Product Change Notification / GBNG-25AASD236

CCB 4801 Final Notice: Implement Edge Protection Technology (EPT) for selected products available in 32L (7x7x1mm), (7x7x0.9mm) and 44L (7x7x0.9mm) VQFN packages at ANAP assembly site.

CCB 4801
Pre and Post Change Summary
PCN #: GBNG-25AASD236

Edge Protection Technology (EPT) mechanism

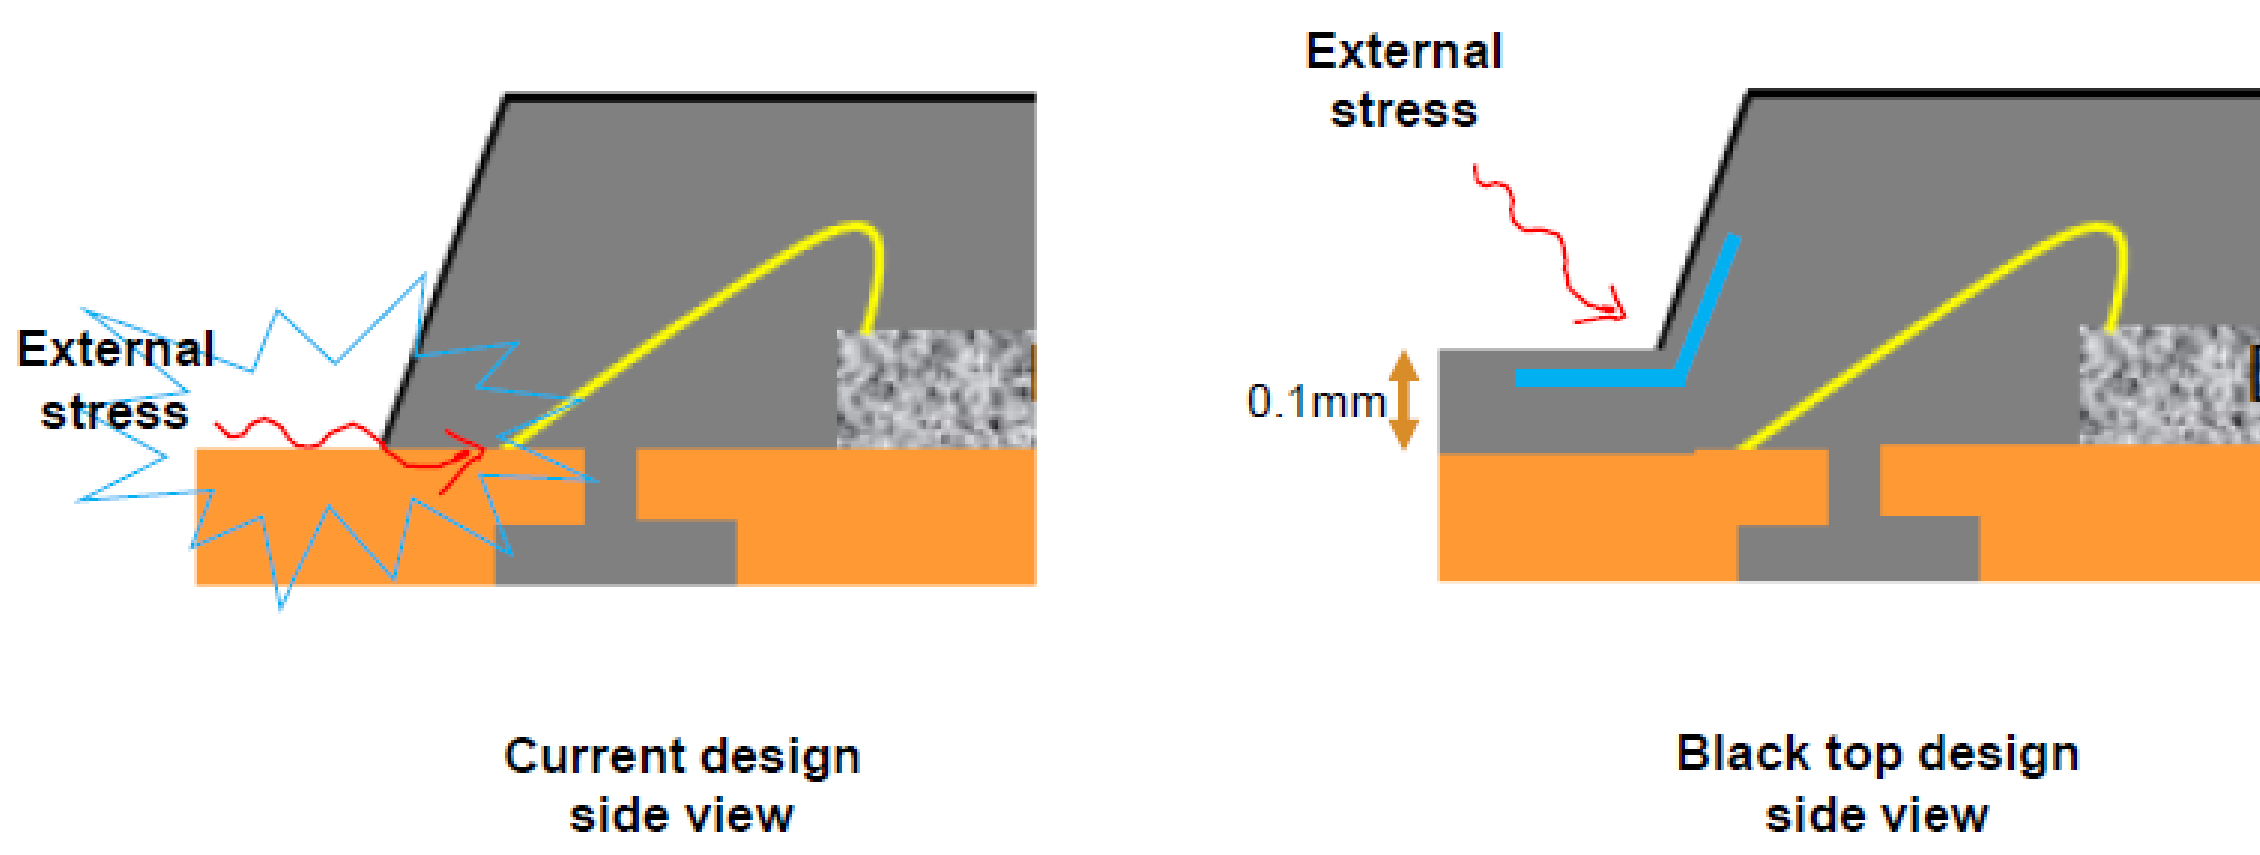
- **With current standard design of Punch QFN, external stress which exceeds pkg flange strength between lead frame and molding compound will penetrate toward stitch bond resulting in stitch broken.**
- **Edge protection design has additional mold cap with 100um on flange area. Additional mold cap will increase pkg strength against fracture which can protect stitch bond from external stress from Assy to board mounting process**

Current design
side view

Black top design
side view

Punch QFN EPT vs Non-EPT POD comparison

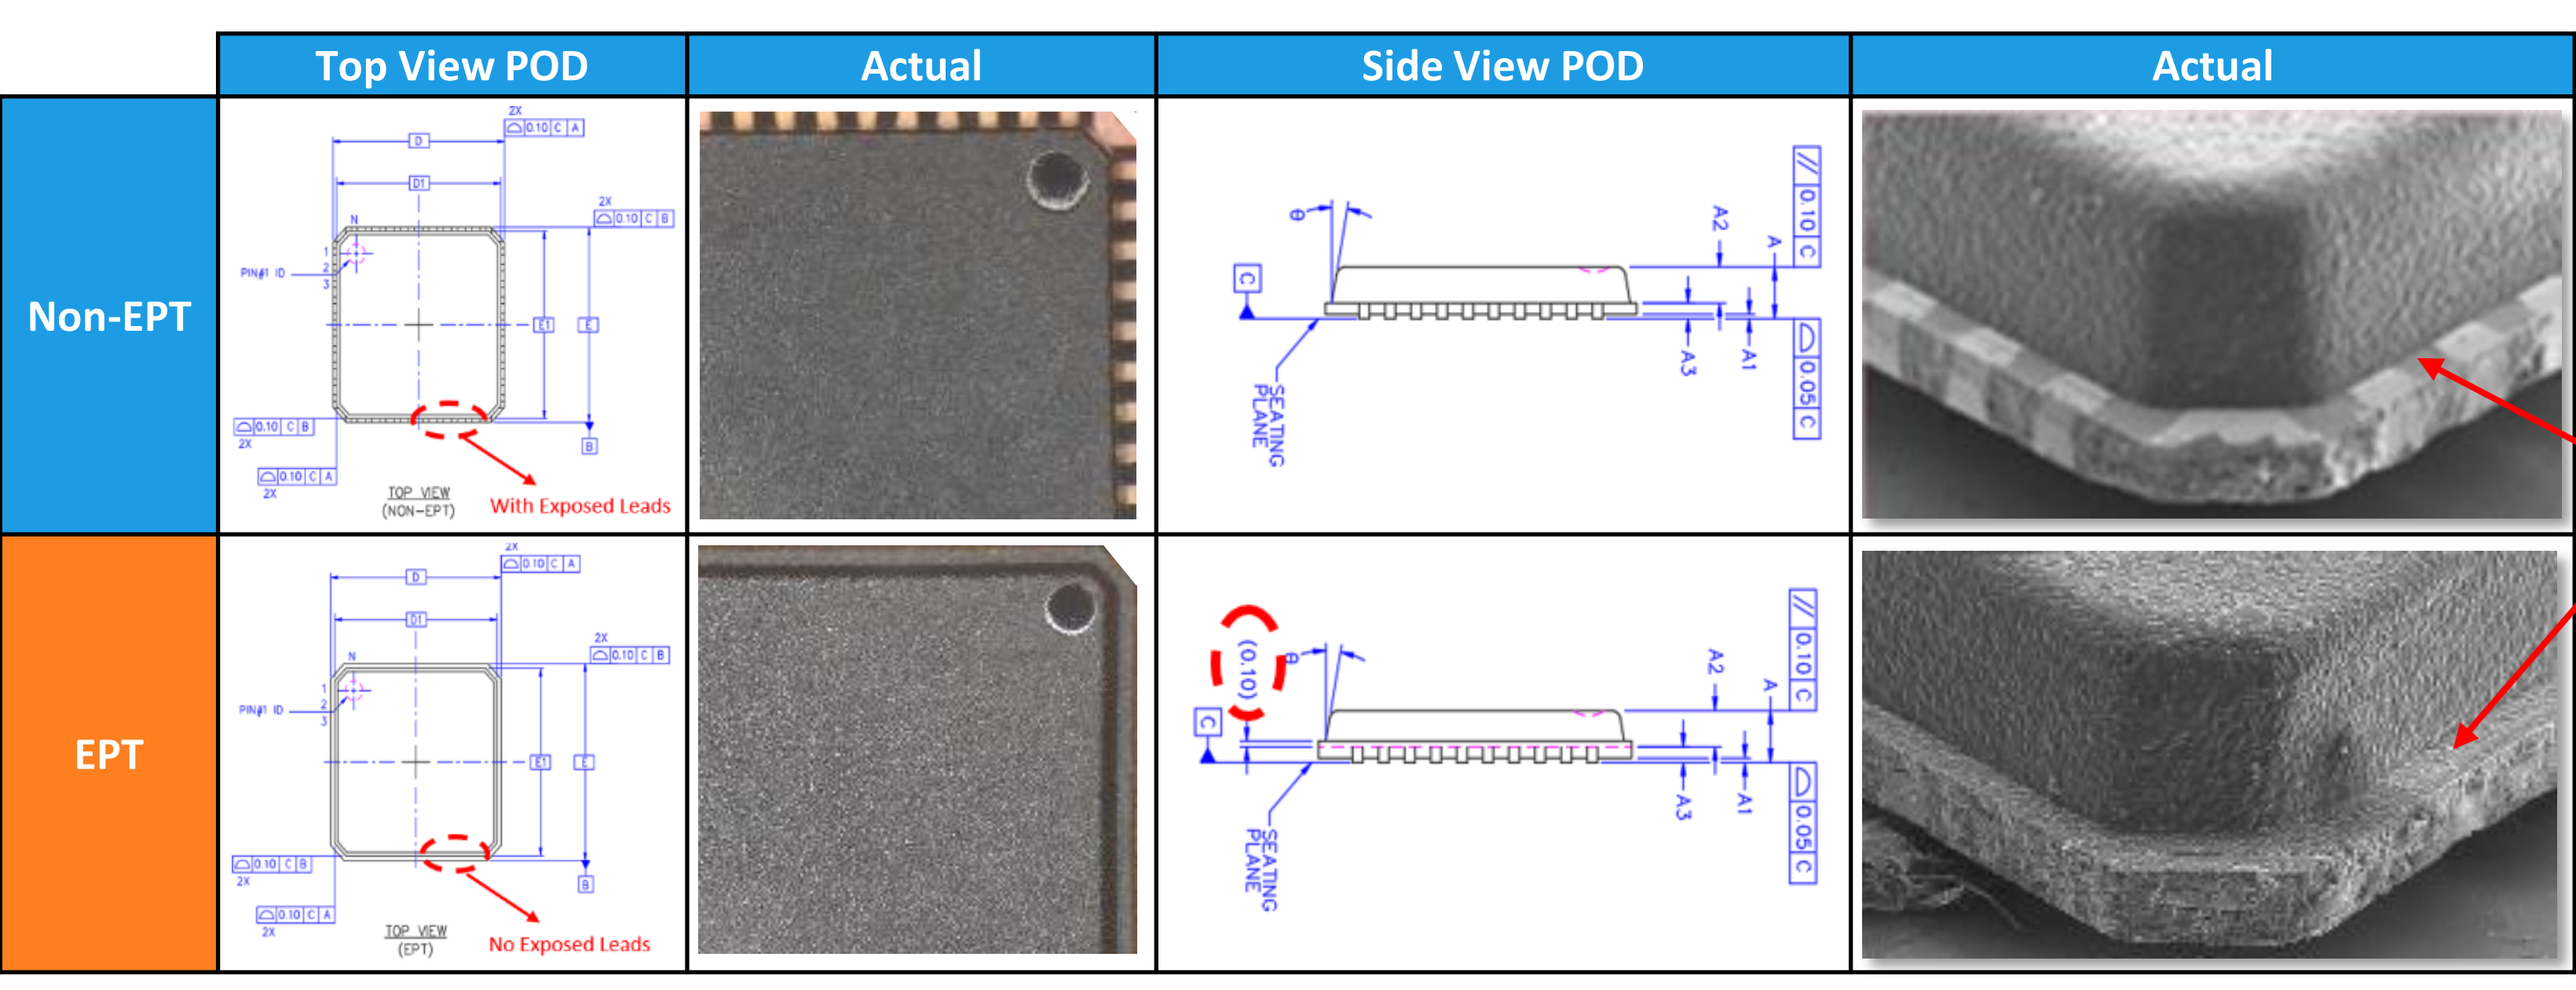
- Lead Pitch, Width, E-Pad size – NO CHANGE due to no change in LeadFrame.
- Overall PKG dimension (D/E) – NO CHANGE. D1/E1 nominal dimension reduced by 0.04mm – see below table.
- Added A3 + EPT to illustrate additional mold covering the top leads.

The top external leads will be covered by Mold Compound for the EPT package.

Symbol	7x7		
	Non-EPT	EPT	MCHP
A	0.85 +/- 0.05	0.85 +/- 0.05	0.85 +/- 0.05
A1	0.0 - 0.05	0.0 - 0.05	0.0 - 0.05
A2	0.65 +/- 0.05	0.65 +/- 0.05	-
A3	0.20 ref	0.20 ref	0.20 ref
A3+EPT	n/a	**0.30 ref**	-
D	7.0 +/- 0.1	7.0 +/- 0.1	7.00 BSC
D1	6.75 +/- 0.1	**6.71 +/- 0.1**	**6.75 BSC**
E	7.0 +/- 0.1	7.0 +/- 0.1	7.00 BSC
E1	6.75 +/- 0.1	**6.71 +/- 0.1**	**6.75 BSC**
